CCK-2590.50-1-25

Asset Preservation Pool - Patterson Office Tower Partial Renovation (5th Floor)

ADDENDUM #3

**UK PATTERSON OFFICE TOWER
FIFTH FLOOR RENOVATION**

COPYRIGHT 2025 - JRA, INC.

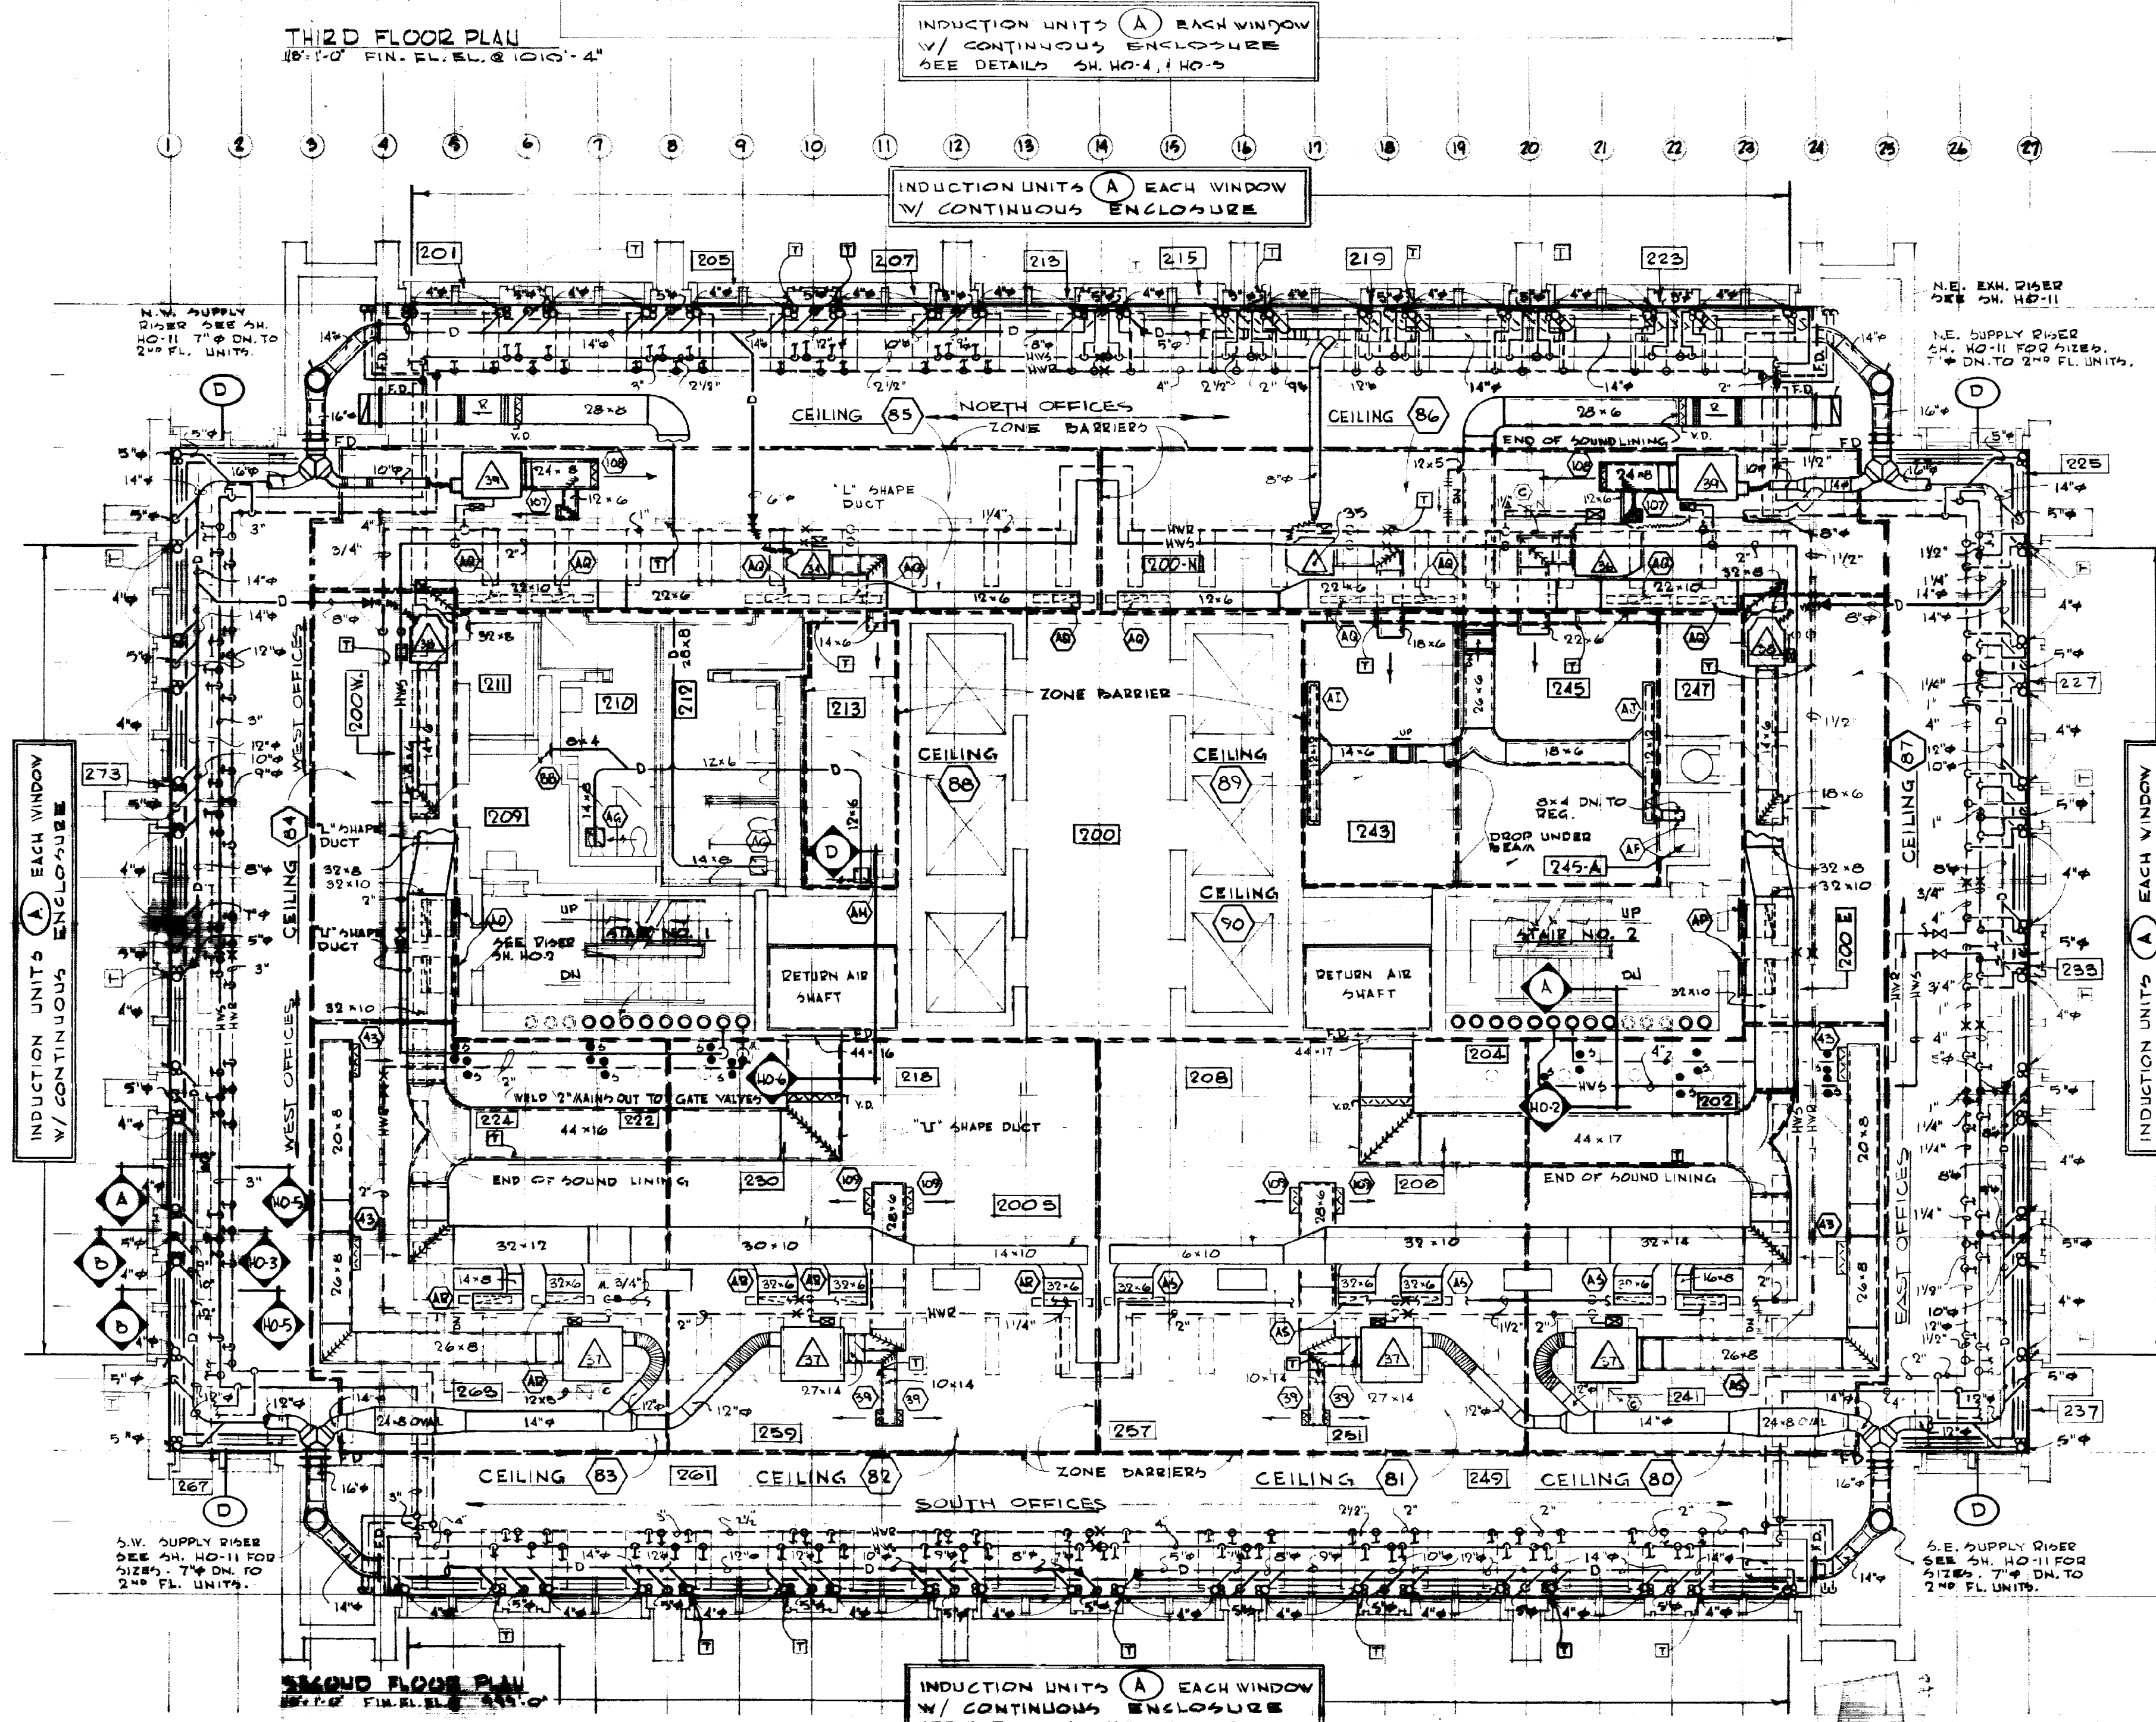
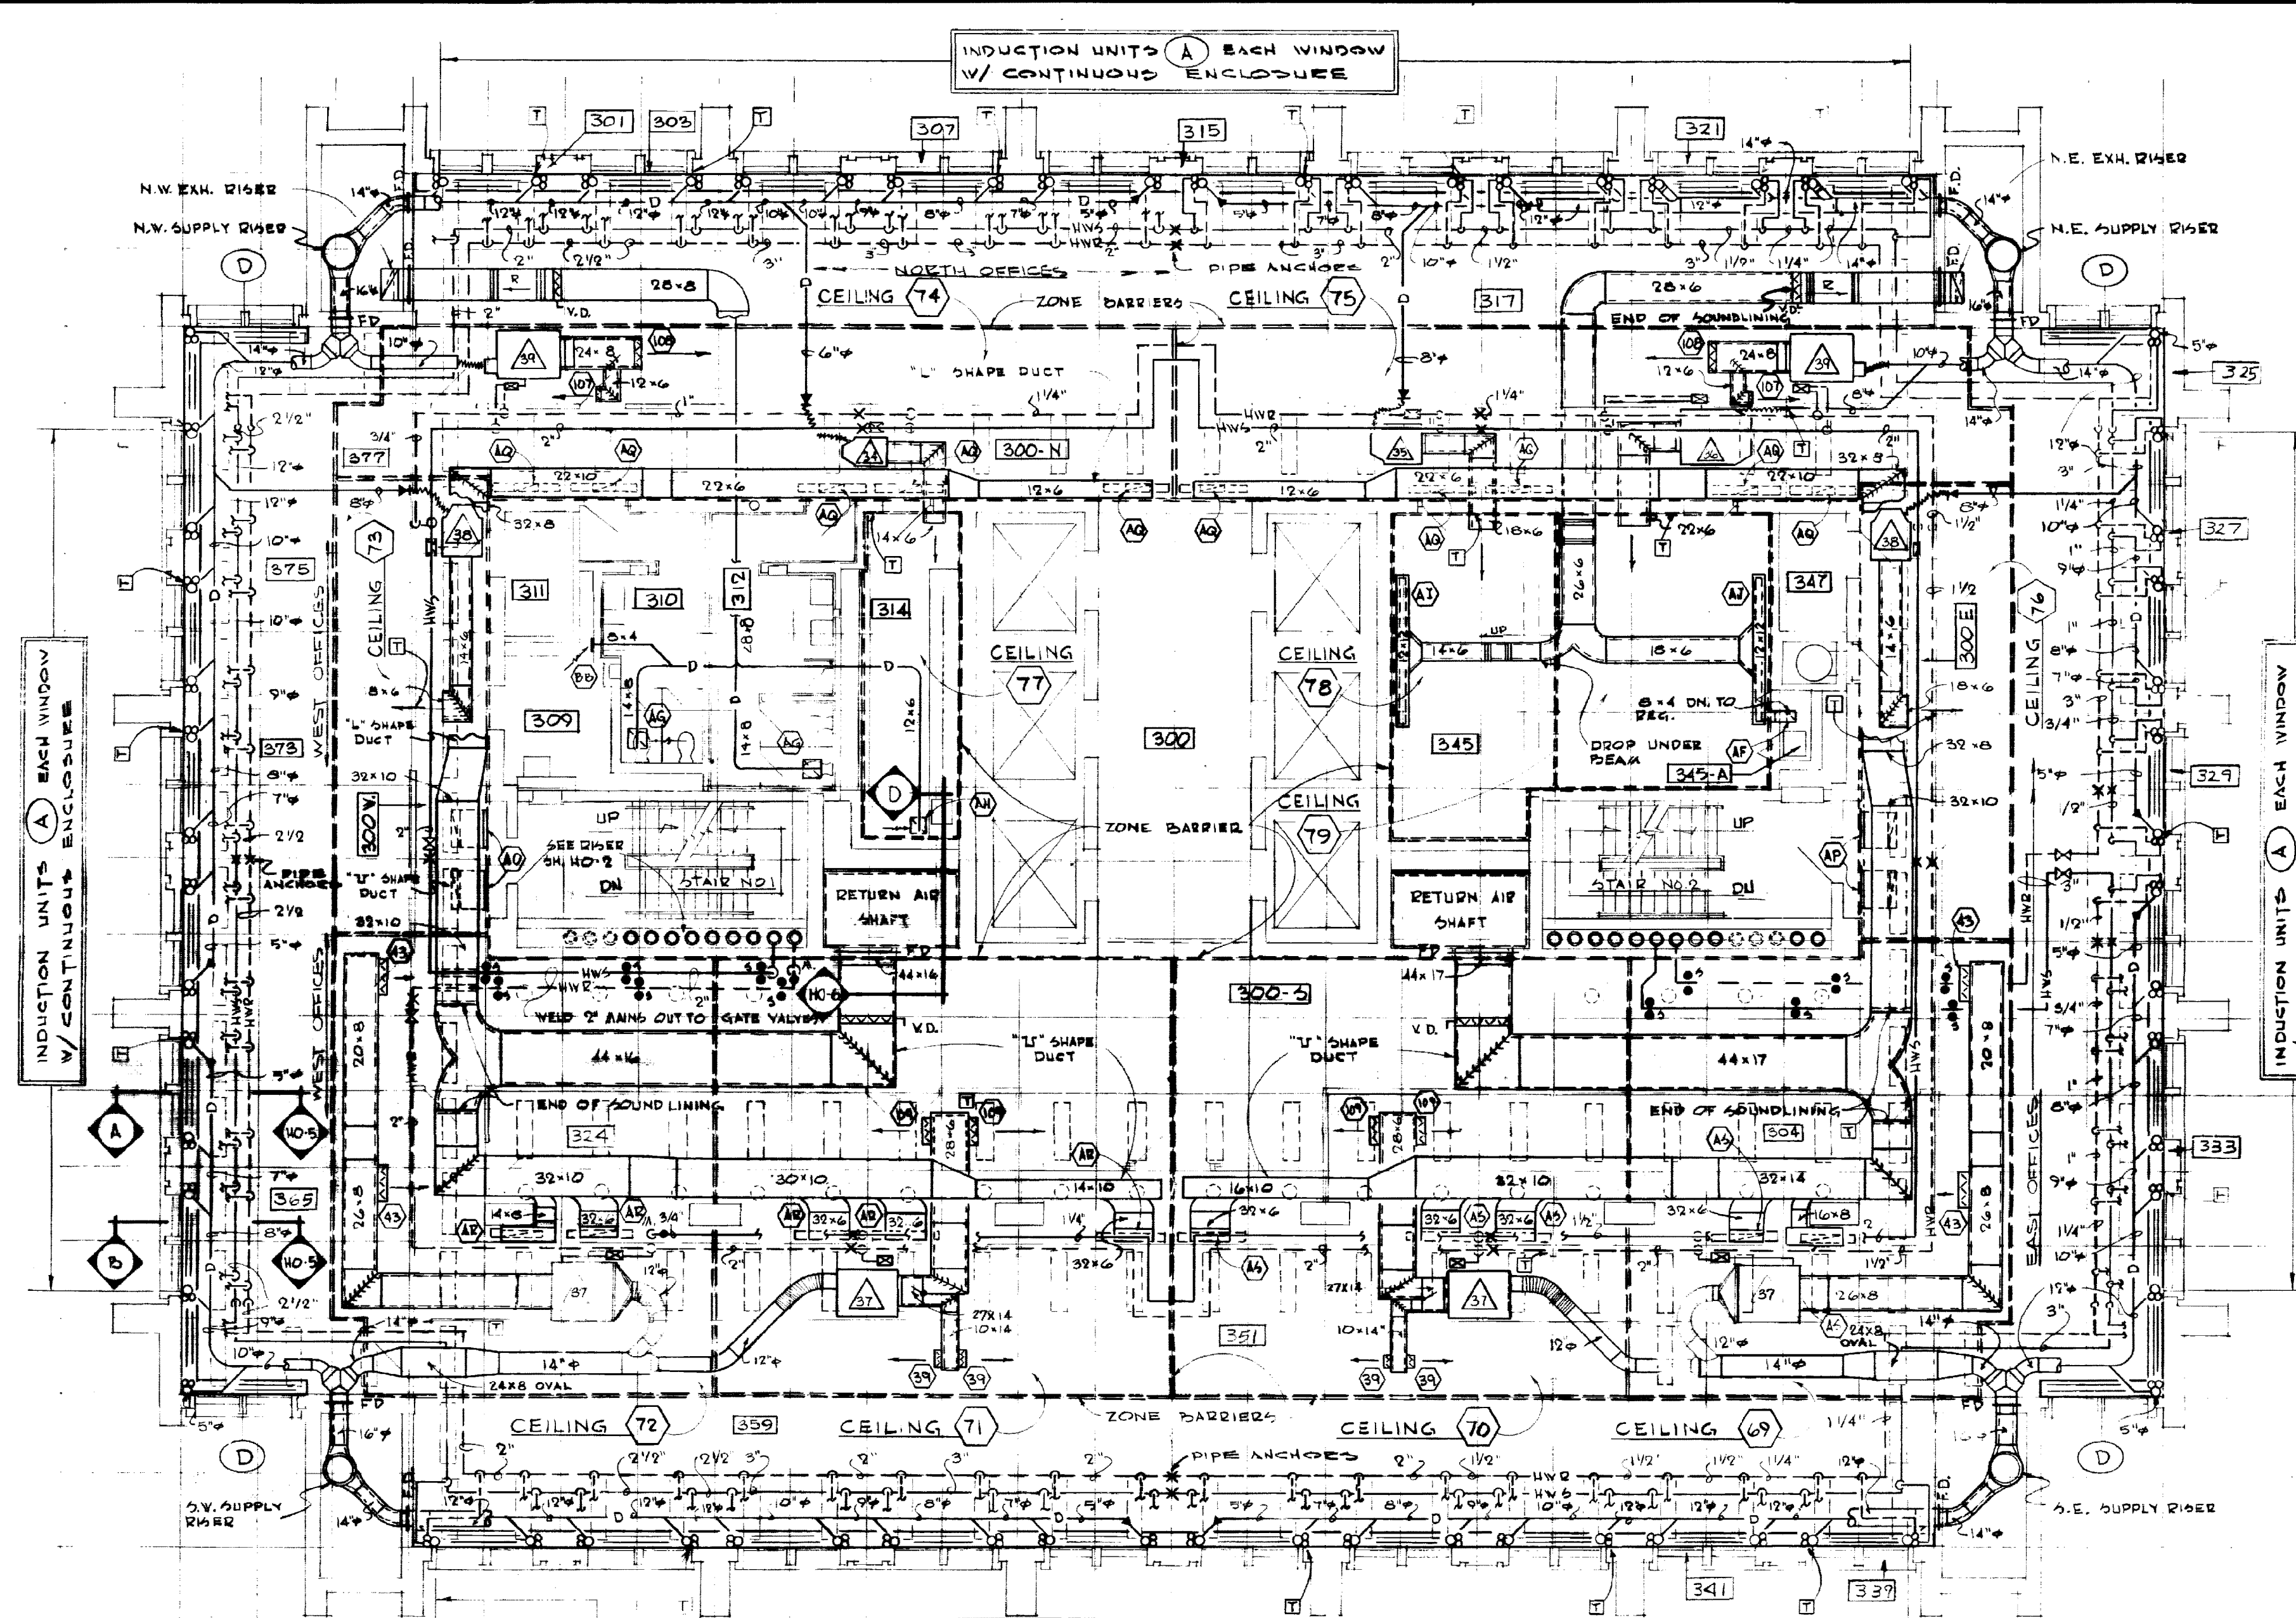
Refer to the attached drawings – the following drawings have been revised and attached to this document:
A-621
